From: [Wolfenbarger, Jeanne](#)
To: [Jessica Charland](#)
Subject: RE: PRT 21-187
Date: Monday, January 31, 2022 3:37:20 PM

RE: PRT 21-187 (Veterinary Clinic on University) - Waiver on Side Walk Requirements

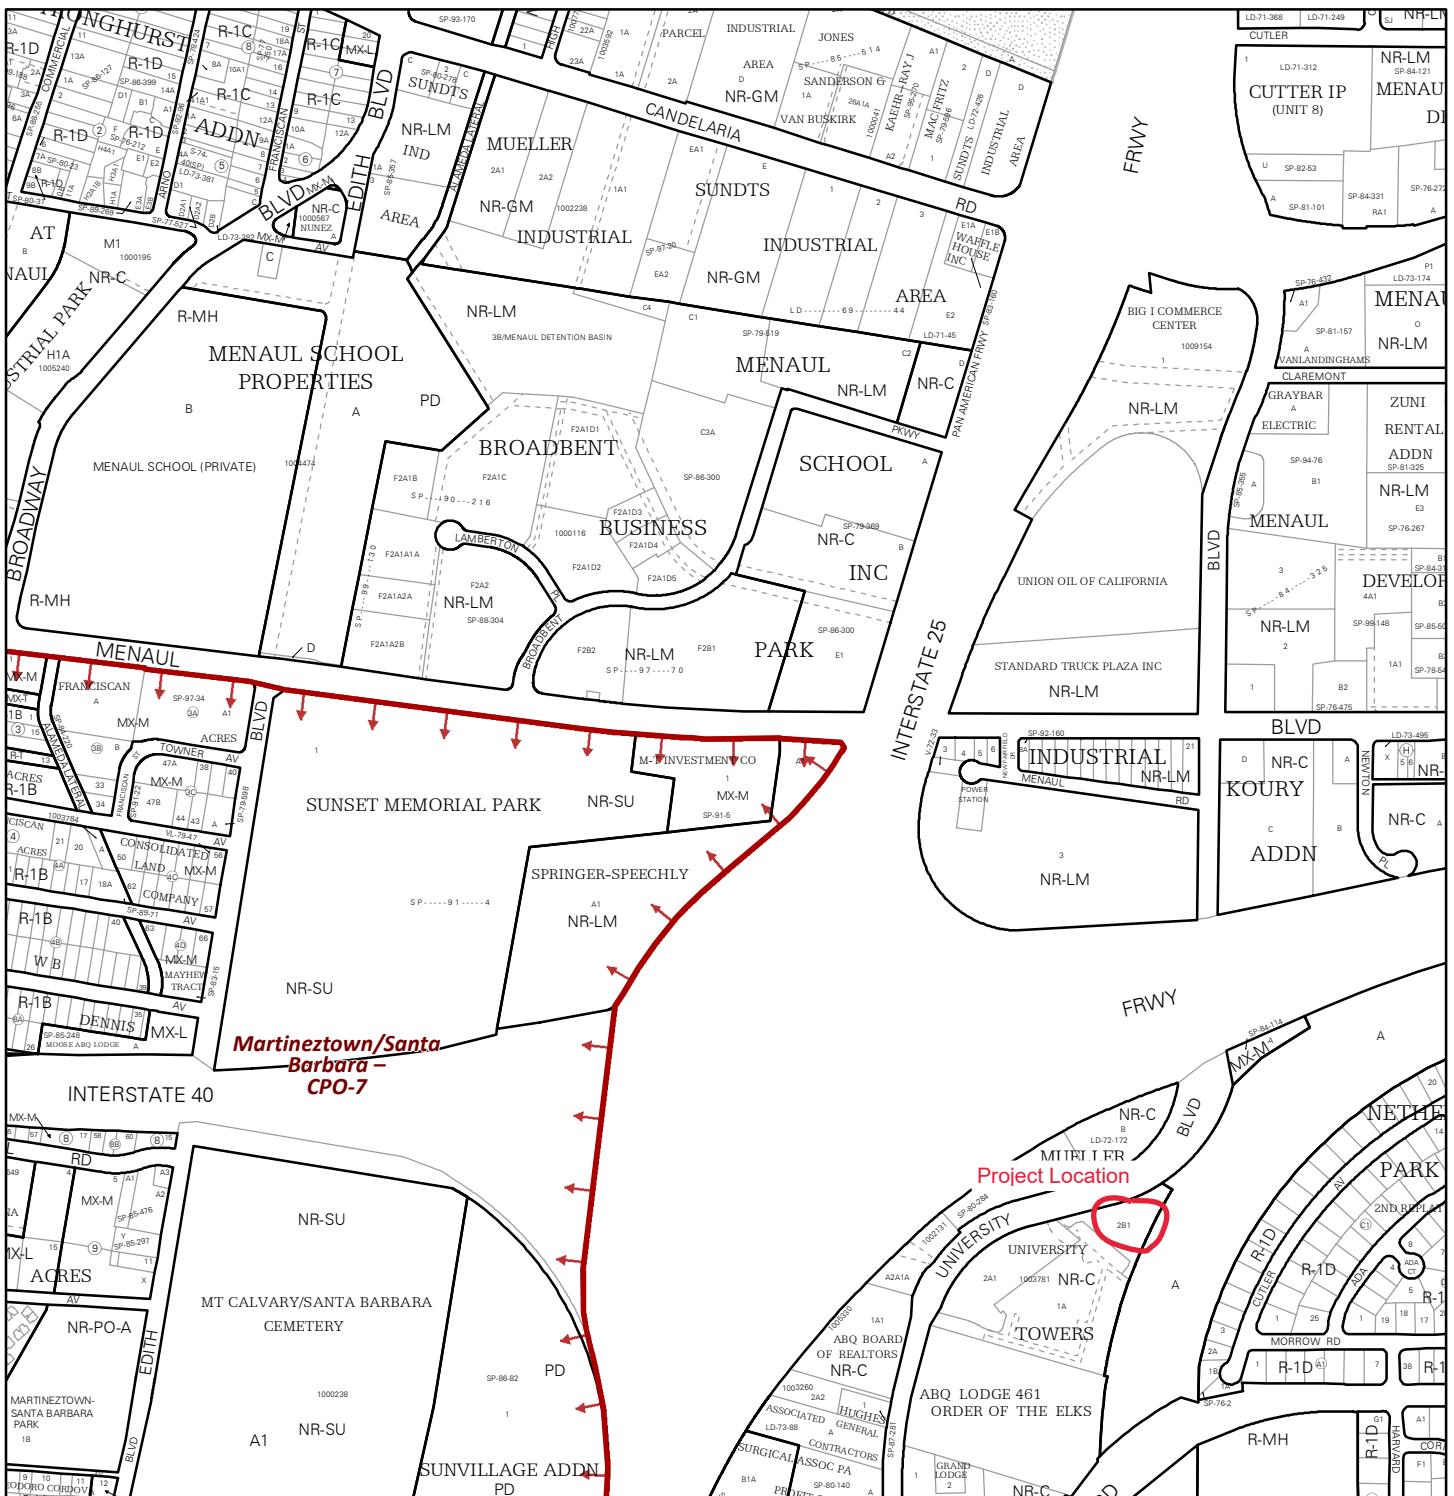
We are requesting a waiver on a requirement to install a side walk along the east side of University Blvd., North of our drive entrance.

There is currently a sidewalk that runs along the east side of University and continues to the entrance of our property. After that entrance, University becomes much steeper and Curves to the North before it hits the I-40 freeway. There are no additional properties along University drive until well after the freeway underpass, a long distance away from our drive entrance. There is also a permanent concrete barricade along that curved portion of University Blvd., that leaves a narrow space between it and a 10' - 20'+ high retaining wall where large road traffic signs, trees and utility vaults are located. Finally, our site and property line are separated from University Blvd. by a distance between 27' to 40', and our site is also 15'+ higher than university Blvd, leaving a steep hill between.

Any improvement to that city right-of way would be extremely costly / cost prohibitive to our property owner.

We have included a site plan and photographs of the areas stated. We are requesting that the existing side walk at the south side of our drive entrance, along with a new sidewalk on our property that follows our drive entrance and connects to our front door meets the requirements of providing a sidewalk along our property line.

Jessica, based on your explanation and circumstances, you may be granted a sidewalk waiver if you are going through the Traffic Circulation Layout process and not the Development Review Board. Make sure to keep all of the files (including files and Zone Atlas Page) together with this determination.
